**MONTGOMERY COUNTY HISTORIC PRESERVATION COMMISSION**  
**STAFF REPORT**

<b>Address:</b>	7500 Carroll Avenue, Takoma Park	<b>Meeting Date:</b>	7/27/2022
<b>Resource:</b>	Contributing Resource <b>Takoma Park Historic District</b>	<b>Report Date:</b>	7/20/2022
<b>Applicant:</b>	Eric Liebmann	<b>Public Notice:</b>	7/13/2022
		<b>Tax Credit:</b>	N/A
<b>Review:</b>	HAWP	<b>Staff:</b>	Michael Kyne
<b>Permit Number:</b> 998950			
<b>PROPOSAL:</b> Converting garage to accessory dwelling unit

proposed site plan

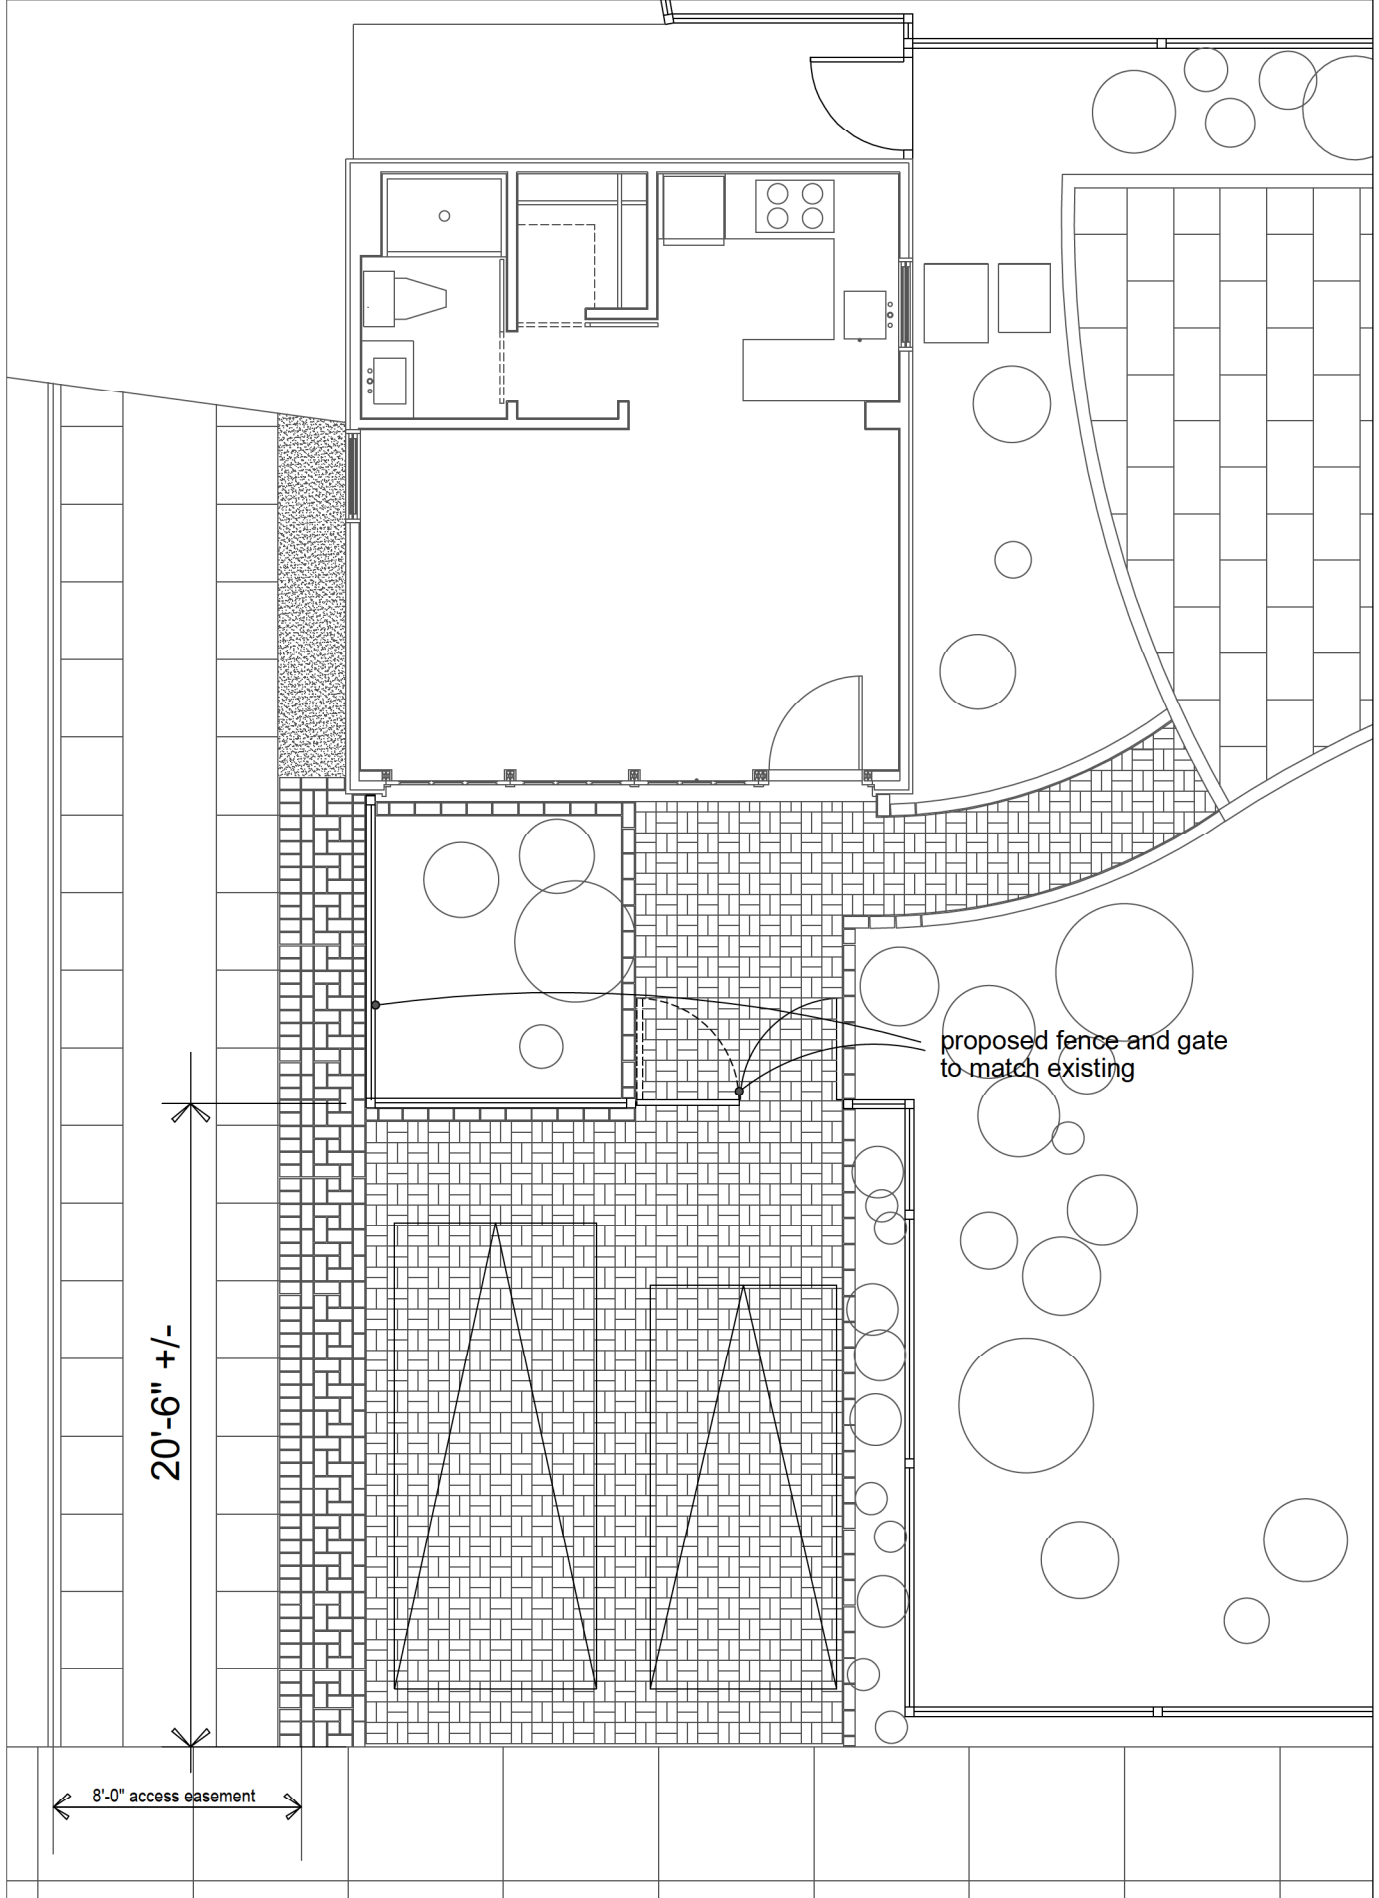
Staff is concerned about the proposed 6' tall solid fence with double gate, which is proposed at the front of the garage. This would obscure much of the garage's primary elevation, and a solid fence/gate directly in front of a garage entrance along a public right-of-way would be incompatible with the historic district and surrounding streetscape. Staff recommends that the proposed fence/gate in front of the garage be a 4' tall wood fence/gate with an open picket design to preserve the visibility of the garage's primary elevation from the public right-of-way. Along with the proposed landscaping and hardscaping alterations and a discernible front entry door, a 4' tall wood picket fence/gate will result in a more residential appearance, while still allowing the building's original function to be clearly discerned. Staff recognizes that the driveway has a slight slope toward the left, and finds that a fence/gate that accommodates for the slope and maintains a level appearance by slightly exceeding the recommended 4' height on the left side would be appropriate.

In conversations with staff, the applicant has discussed moving the location of the proposed double gate from the right side of the driveway to the middle of the driveway. Staff finds that this would be an appropriate option, as it would recall the ability to drive up to the garage; however, staff would also support keeping the double gate at the right side of the driveway, as depicted in the current proposal. Staff recognizes that each option may require a different configuration of the proposed landscaping and hardscaping in front of the garage, and recommends that the applicant work with staff for final review and approval of the gate location.

Staff recommends the following condition of approval to make the proposal appropriate and compatible with the subject property and surrounding streetscape: **The proposed fence/gate will be a 4' tall wood picket fence/gate, with final review and approval of the proposed fencing and associated landscaping and hardscaping delegated to staff.**

proposed elevation

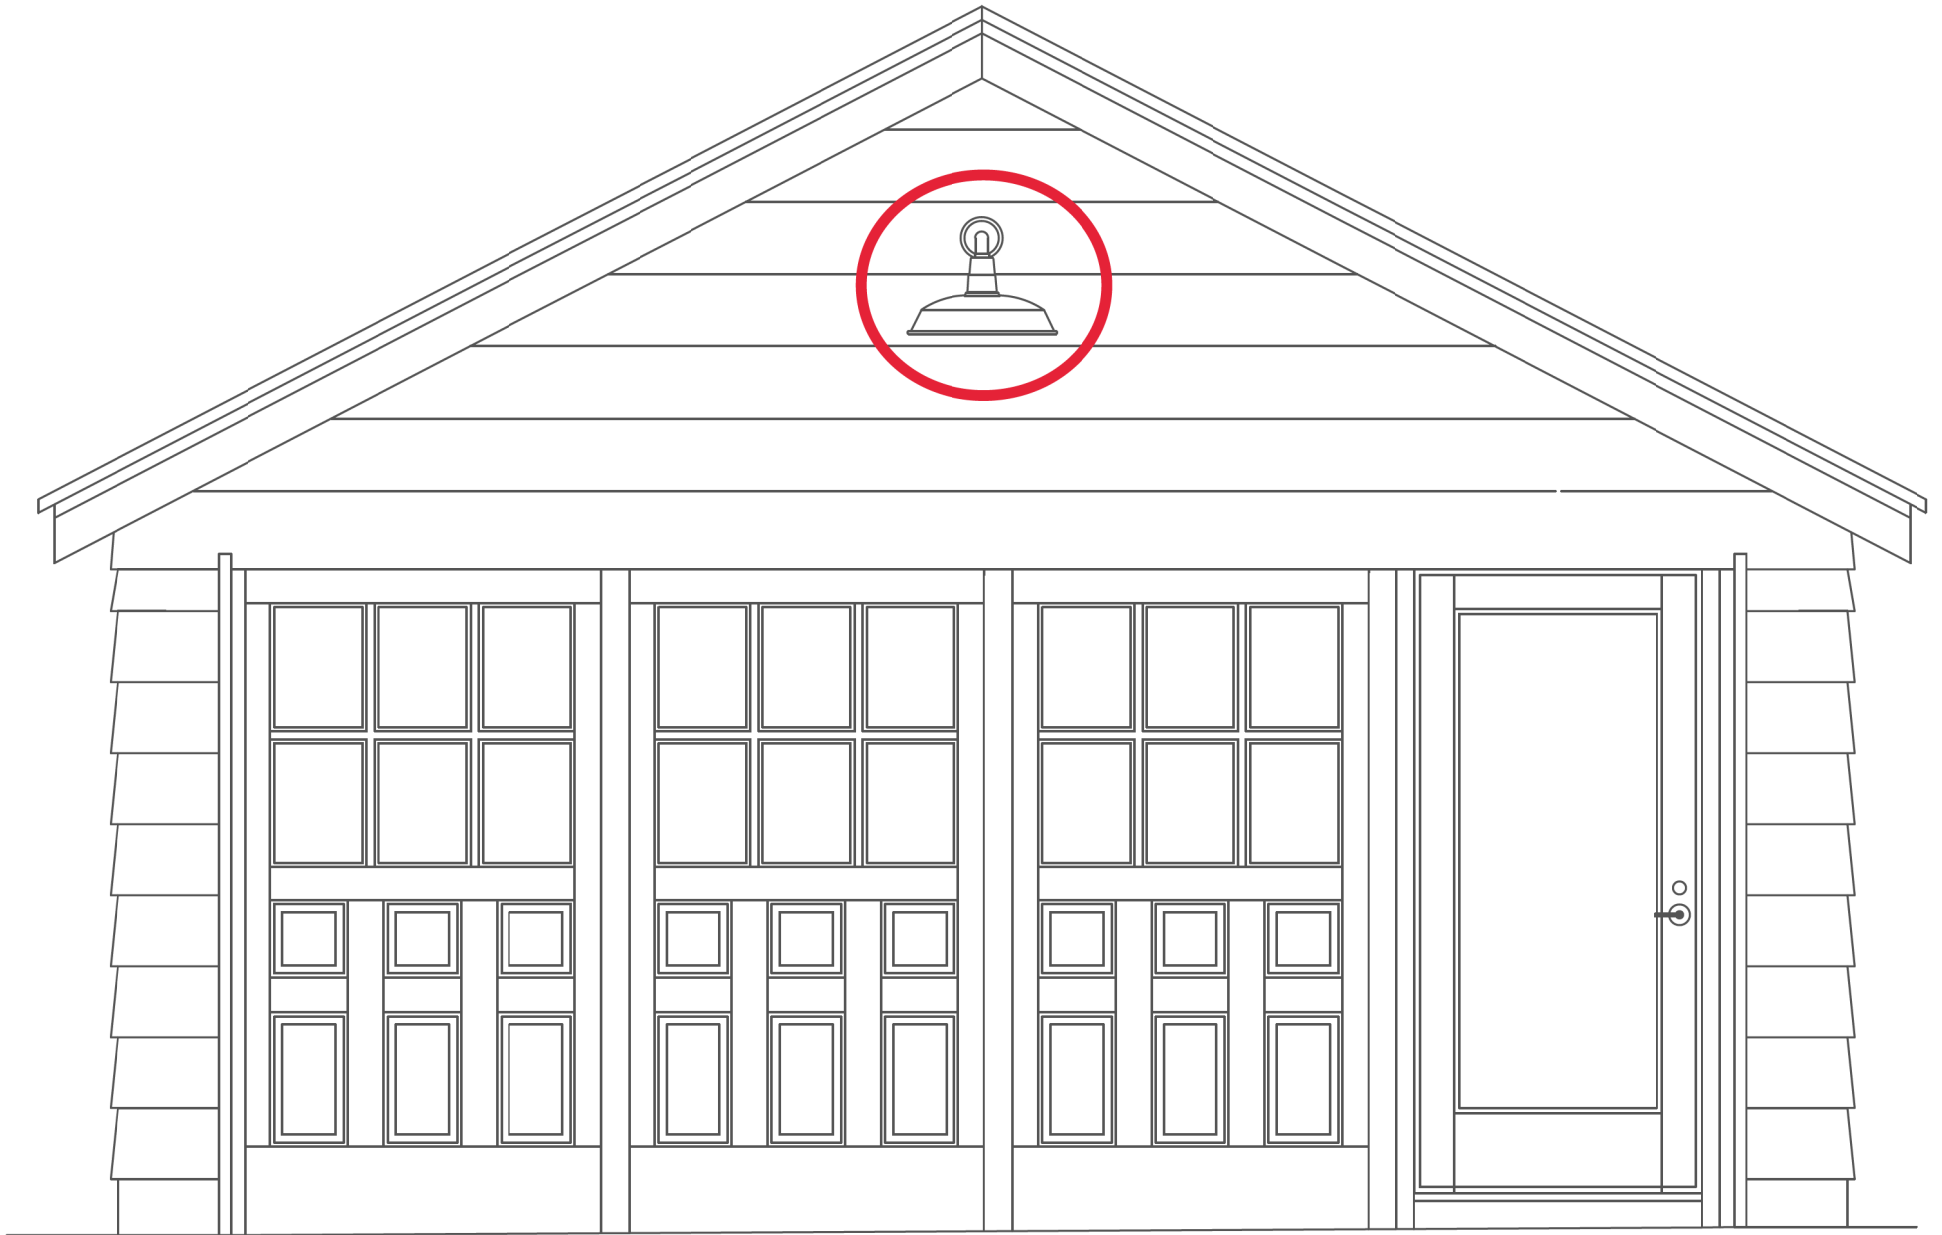
Staff is generally supportive of the applicant's proposal. The window to be altered at the rear of the garage is not visible from the public right-of-way, and the existing opening will be framed and infilled with a solid wood board, leaving the original opening discernible. The window will also be reused, replacing the entry door on the right side of the garage, which appears to be a previous replacement. The lower section of the door opening under the relocated window will be infilled with compatible wood siding to match the existing.

While the sliding garage door panels at the front of the garage are original, they are currently non-functioning. The proposal will preserve three of the original door panels, fixing them in place, while providing a new, compatible use for the building. This will provide additional living space at the property without the need for an addition to the historic house. Staff would prefer that the fourth door panel be retained, but the front of the garage is the most viable location for an entry to the proposed ADU, given the location of the building, proposed floor plan, and site configuration (there is a driveway easement for the neighboring property directly adjacent to the left side of the garage). Staff contacted the applicant to discuss the possibility of converting the original fourth door panel to an entry door, but the applicant stated that the size and weight of the door panel make this option impractical.

In this case, staff finds that a new entry door with a lite pattern that more closely matches the design of the existing garage door panels (six-lite/three-lite, double-row pattern) may not be the preferred option.

With the required framing and reduced width, the new entry door would necessarily have fewer or smaller lites. The number/dimensions of the recessed lower panels would also differ. Staff finds that a similar yet incongruent entry door directly adjacent to the original door panels may not convey the building's adapted use and result in a jarring appearance. The applicant's preference is a full-lite, wood-framed entry door to allow more natural light into the garage. Staff finds that this is an acceptable option, which will not significantly detract from the character of the building.
